**LEANNE TOBIAS
ZONING OFFICER & BOARD MEMBER
SPRINGFIELD BETHESDA CIVIC ASSOCIATION
LITTLE FALLS PARKWAY
WRITTEN TESTIMONY
to the
MONTGOMERY COUNTY
PLANNING BOARD
March 30, 2023**

Little Falls Parkway: Against No-Median Configuration and Permanent Lane Closures

Little Falls Parkway Transportation Analysis

Figure 11: Alternate B, Trail Reorientation to Arlington Road Signal

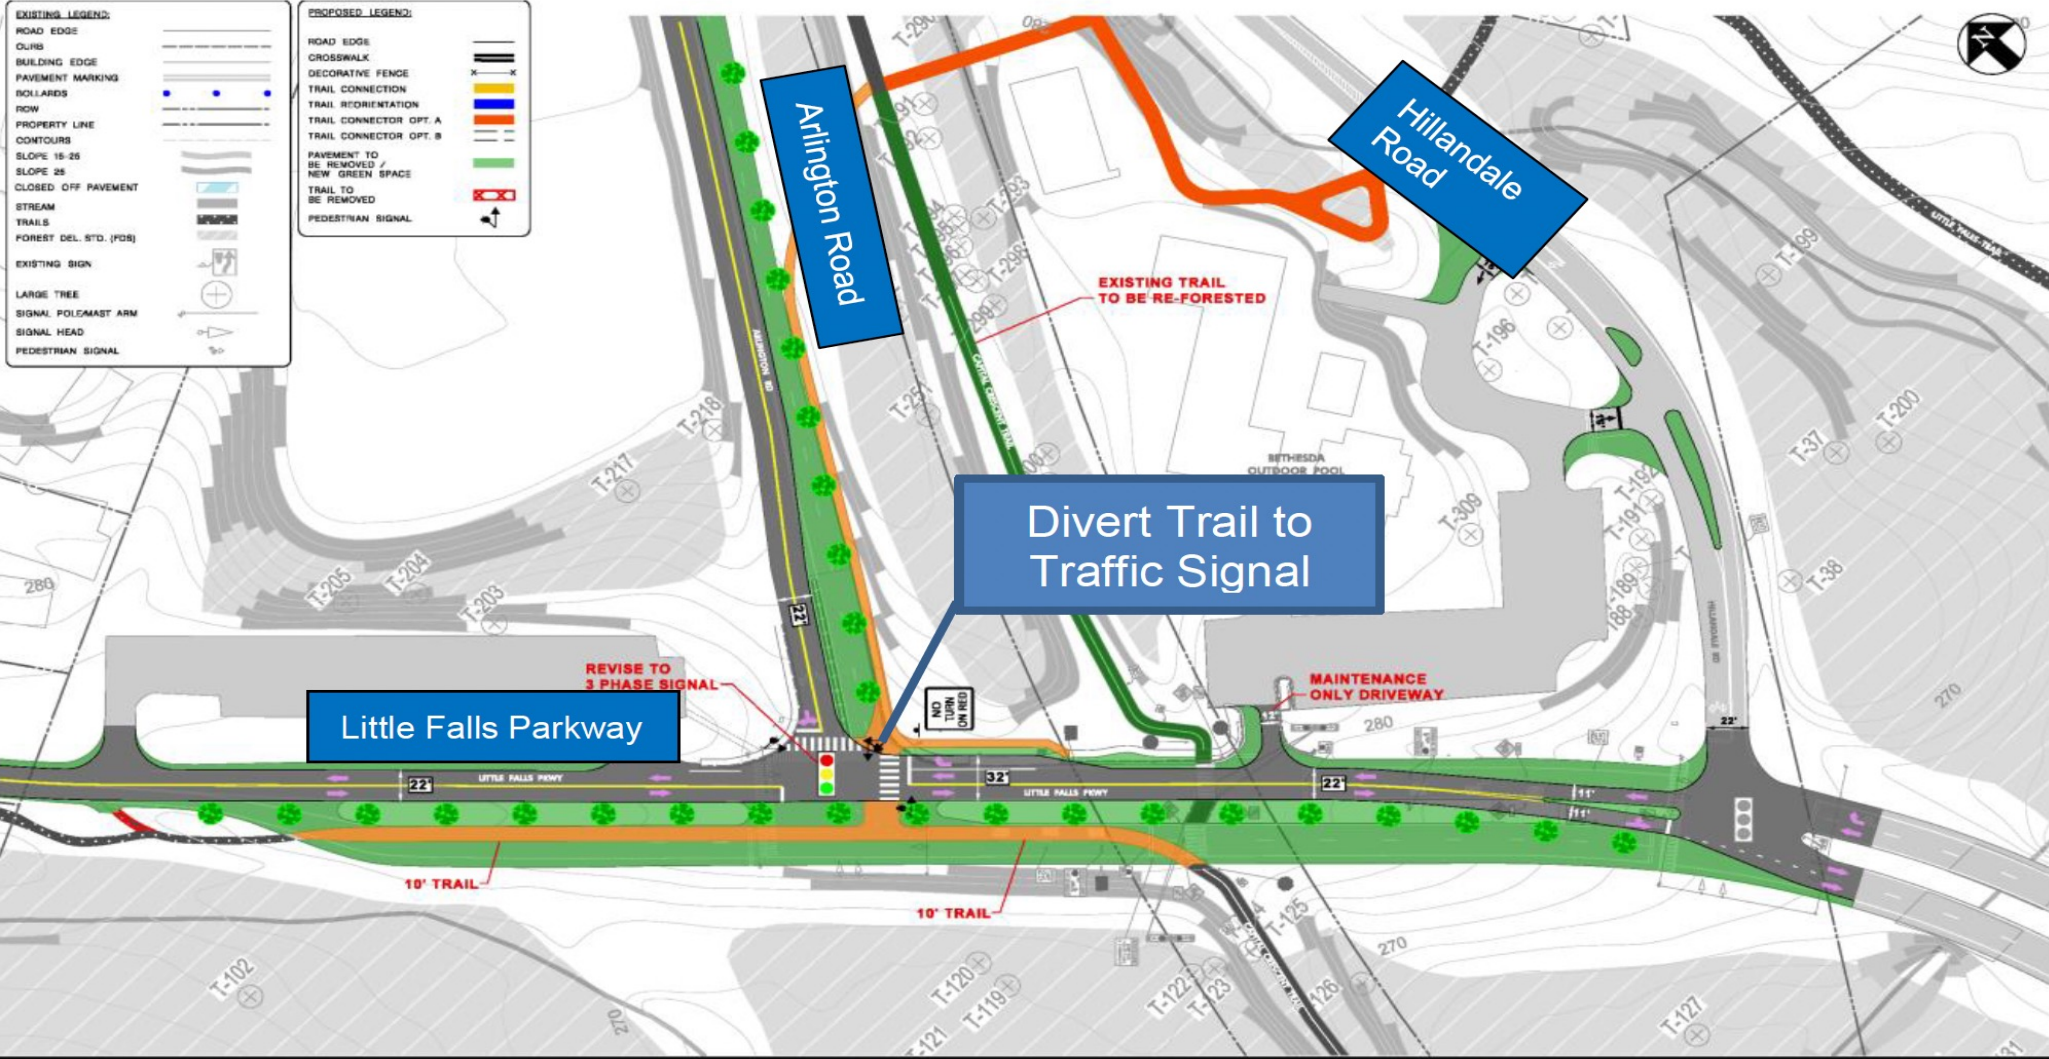
Unpacking Alternative B - From Page 4 of MoCo Parks March 30, 2023 Memo

“With the success of the road diet at the CCT crossing in improving trail user safety, Parks presented a Facility Plan recommendation to the Montgomery County Planning Board in June 2019 to build upon the interim road diet with a permanent two-lane Parkway cross-section from Arlington Road to Hillandale Road. The May 2019 County Planning Board memorandum, *Facility Plan Recommendation for Capital Crescent Trail Crossing at Little Falls Parkway Safety Improvements Project*, contains additional information and concept plans. The Planning Board asked Parks to study re-alignment of the CCT trail crossing to the intersection with Arlington Road, with an improved pedestrian signal. The requested re-alignment had been studied during development of the facility plan but was ultimately **not recommended by Parks staff due to increased travel delays for vehicles as well as trail users**. ~ Per the 2019 Facility Plan, re-aligning the trail to the Arlington Road signal requires a dedicated pedestrian crossing only phase **that increases delays and travel times for all users**”

- Parks is trying to implement a plan that wasn't even proposed in 2019. Instead of reducing vehicle lanes for just one block as previously proposed in Alternatives A&B (Arlington to just before Hillandale) **vehicle lanes were halved for half a mile of roadway (Arlington to Dorset Ave), a dangerous chicane was added which was never part of previous Sabra designs, the roadway is now undivided, and traffic now backs up in both directions during commuting hours. The point: The current roadway design is even less sensitive to travel delays, pedestrian, and vehicle safety.**

Then lets Re-Consider Alternative B, but improved

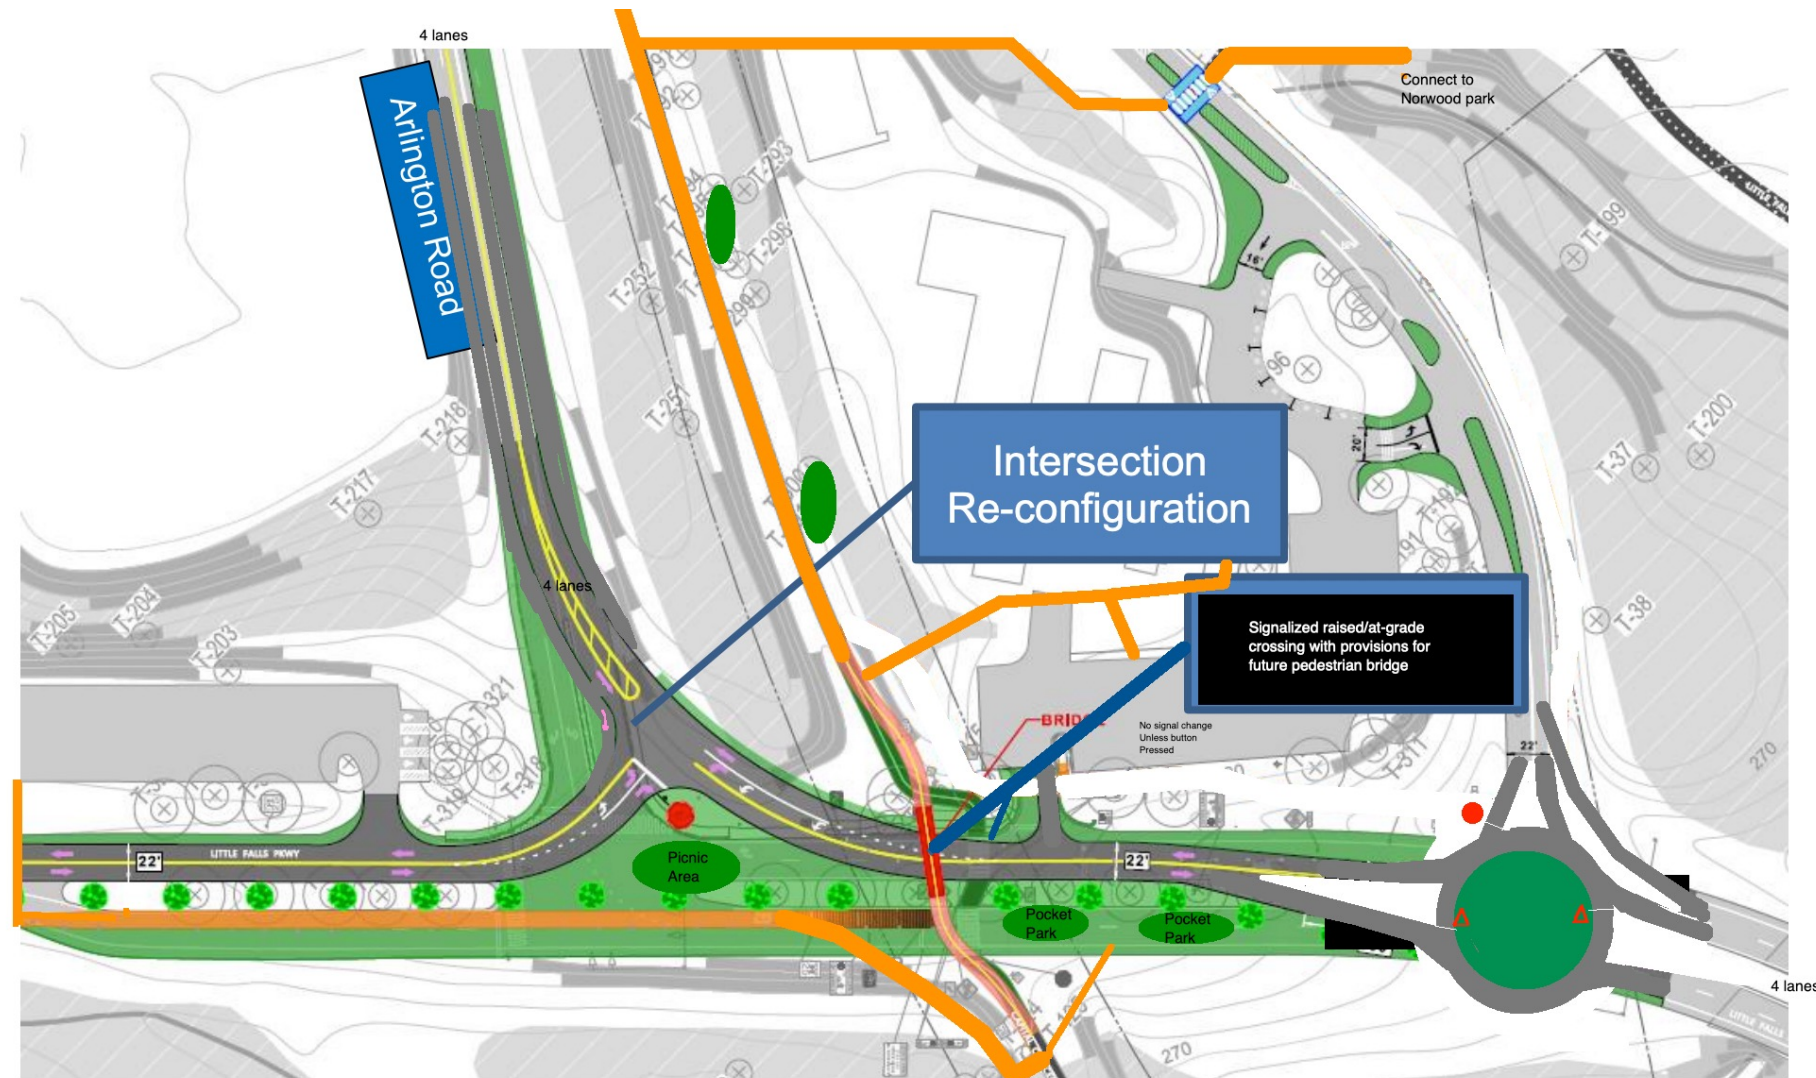
Divided roadway = safer

Linear Park to the left of pool = better location ...or running loop

Several pocket parks

Figure 10: Alternate A: Permanent Road Diet (As Presented At Community Meeting #2)

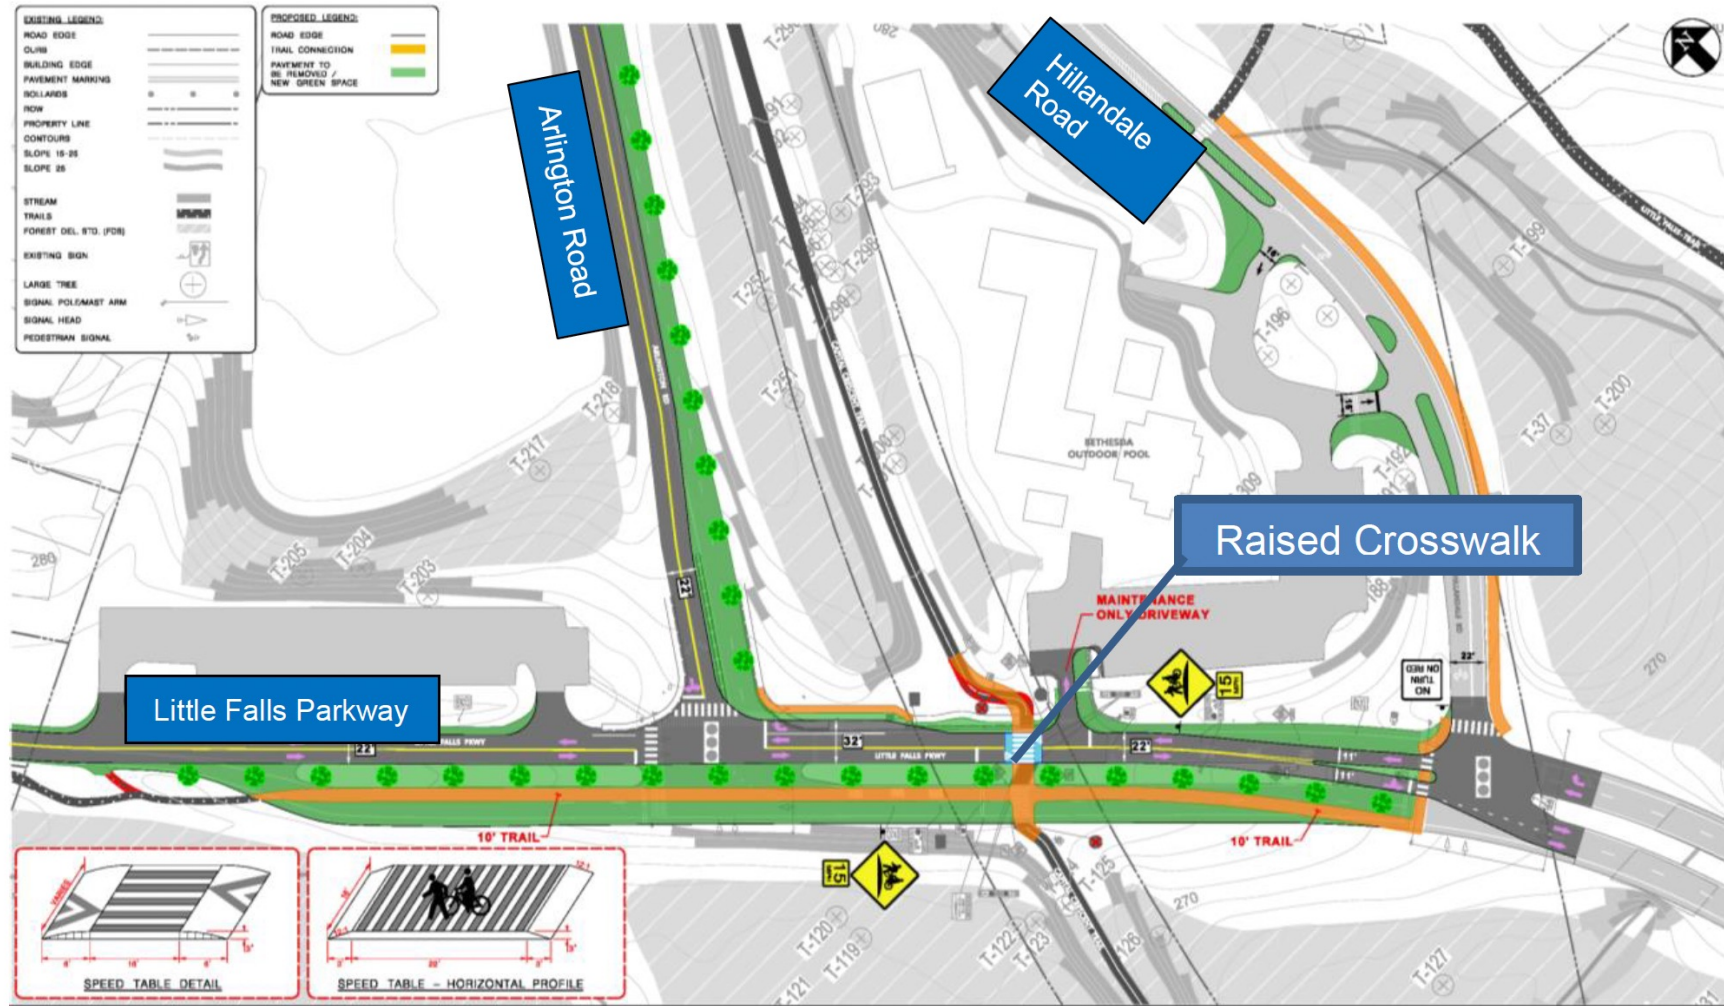
....4 lanes
to Dorset

- The current roadway alignment more resembles alternative A except none of Sabra's designs proposed halving vehicle lanes south of Bethesda Pool - **Parks slipped in this significant change which causes more delays and subjects drivers to a more dangerous undivided roadway with confusing chicane** – This attempt to implement the current Linear Park design proves **the democratic process has failed here.**

Figure 11: Alternate B, Trail Reorientation to Arlington Road Signal

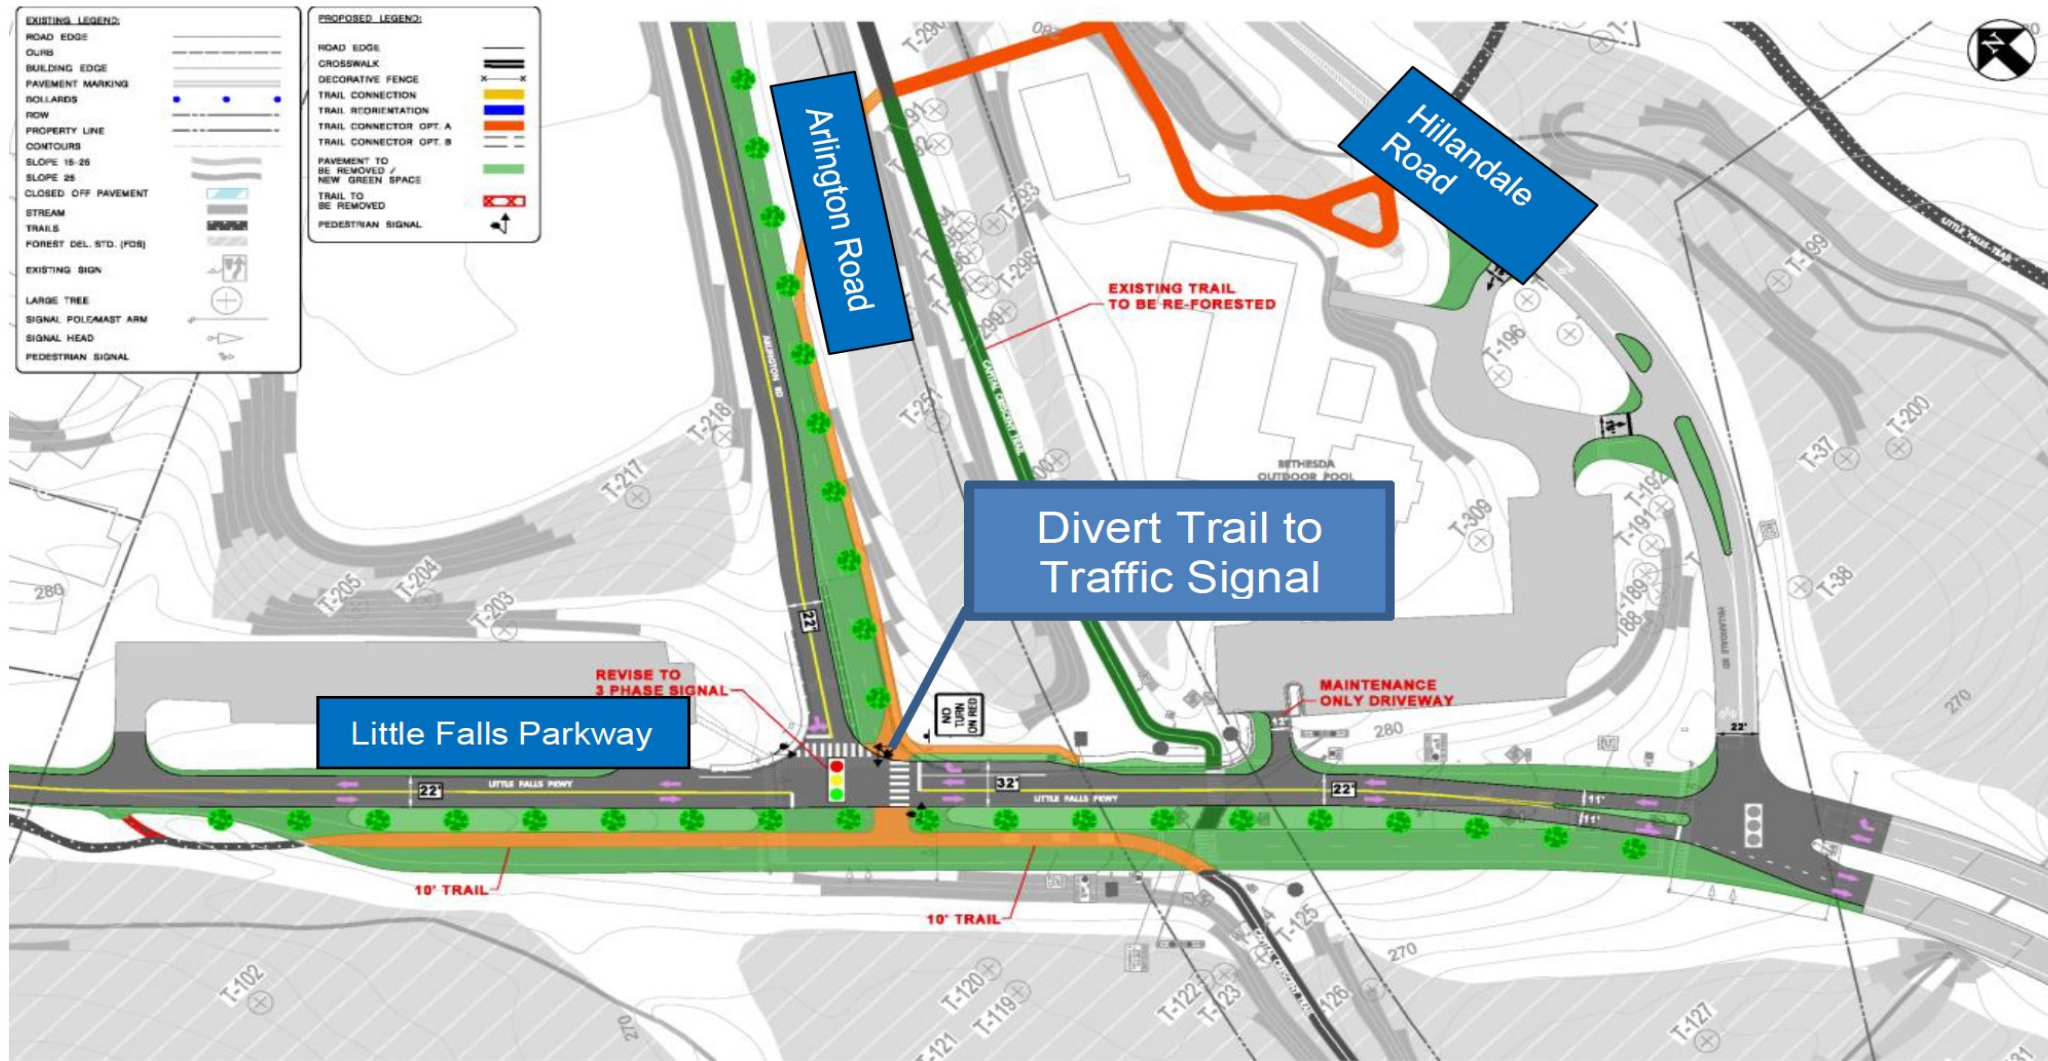
Unpacking Alternative B - From Page 4 of MoCo Parks March 30, 2023 Memo

“With the success of the road diet at the CCT crossing in improving trail user safety, Parks presented a Facility Plan recommendation to the Montgomery County Planning Board in June 2019 to build upon the interim road diet with a permanent two-lane Parkway cross-section from Arlington Road to Hillandale Road. The May 2019 County Planning Board memorandum, *Facility Plan Recommendation for Capital Crescent Trail Crossing at Little Falls Parkway Safety Improvements Project*, contains additional information and concept plans. The Planning Board asked Parks to study re-alignment of the CCT trail crossing to the intersection with Arlington Road, with an improved pedestrian signal. The requested re-alignment had been studied during development of the facility plan but was ultimately **not recommended by Parks staff due to increased travel delays for vehicles as well as trail users**. ~ Per the 2019 Facility Plan, re-aligning the trail to the Arlington Road signal requires a dedicated pedestrian crossing only phase **that increases delays and travel times for all users**”

- Parks is trying to implement a plan that wasn't even proposed in 2019. Instead of reducing vehicle lanes for just one block as previously proposed in Alternatives A&B (Arlington to just before Hillandale) **vehicle lanes were halved for half a mile of roadway (Arlington to Dorset Ave), a dangerous chicane was added which was never part of previous Sabra designs, the roadway is now undivided, and traffic now backs up in both directions during commuting hours. The point: The current roadway design is even less sensitive to travel delays, pedestrian, and vehicle safety.**

Then lets Re-Consider Alternative B, but improved

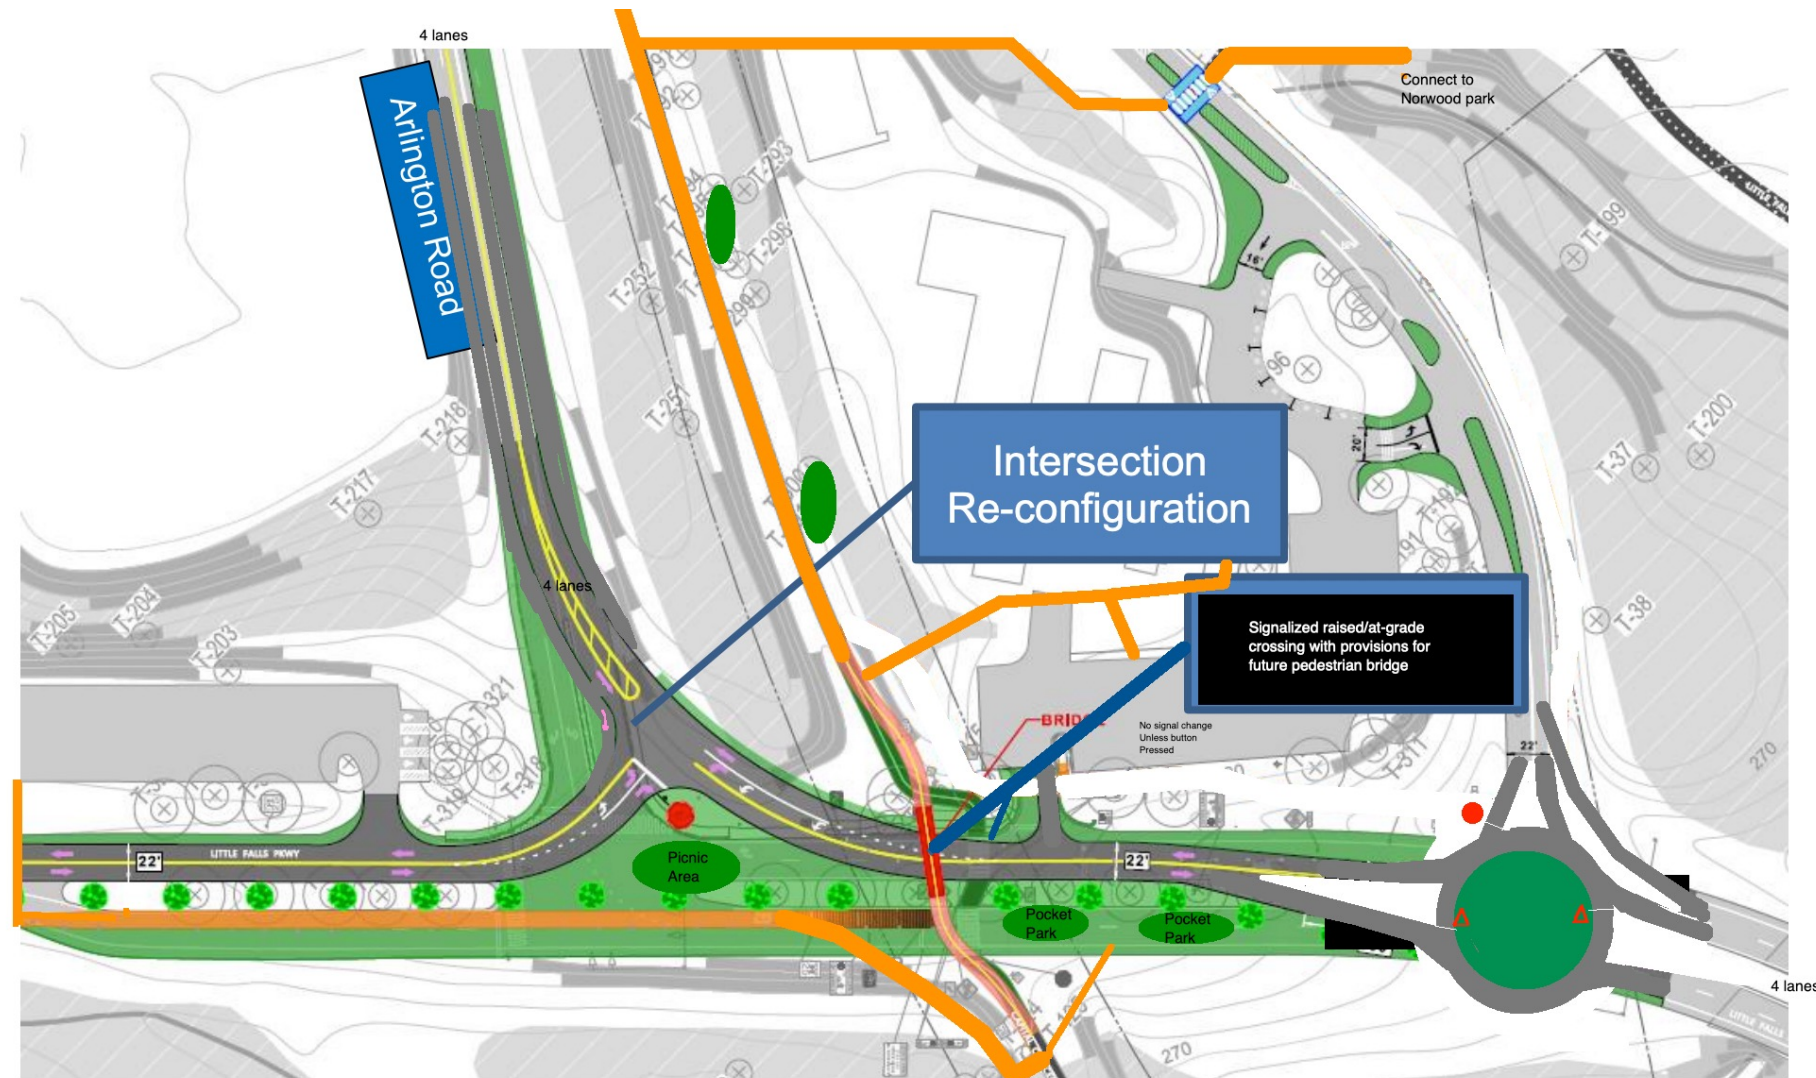
Divided roadway = safer

Linear Park to the left of pool = better location ...or running loop

Several pocket parks
